RE: 2601 Juan Tabo N.E. Revised Drainage Plan

RE: 2601 JUAN TABO N.E. REVISED DRAINAGE PLAN - (H21-DT1

REF: 2601 JUAN TABO NE (H21-D4)

GRADING & DRAINAGE PLAN
FOR
SANTA ANNA PLAZA
2601 Juan Tabo N.E.
Albuquerque, N.M.

SKETCH PLAN OF
2601 Juan Tabo NE
(not to Scale)

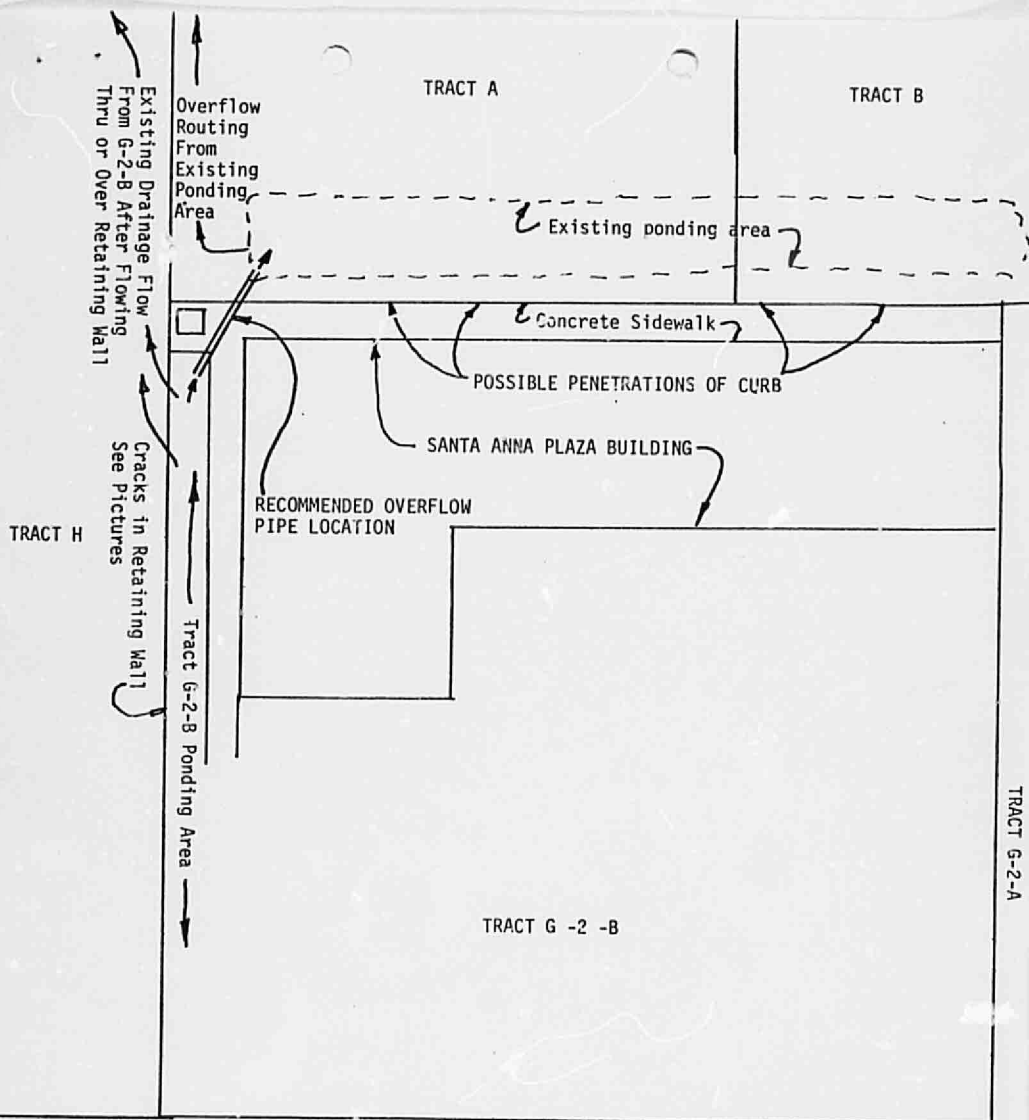
Please refer to the attached sketch plan and the attached photographs numbered (1) thru (8).

The above mentioned Drainage Report for the Juan Tabo 2500 Addition anticipated that all overflow drainage from Tract G-2-B would be directed westerly across the west line of that tract and into the ponding area provided on the rear of Tracts A & B. That drainage Report further contemplated that there would be NO drainage cross the south line of Tract G-2-B onto your property. Subsequently, the pond on Tract A & B along with the outflow therefrom was designed accordingly. Unfortunately, the pond area on the west end of your property was not designed to take any extra drainage from Tract G-2-B.

As an alternative, we suggest that it would be better to fulfill the intent of the original Drainage Report by placing an overflow pipe from the indicated ponding area on Tract G-2-B, underneath the sidewalk at the southwest corner of the building, and thru the rear fence to discharge into the existing pond on the rear of Tract A. This installation would be fairly simple to do and would involve only a minor cost to Tract G-2-B.
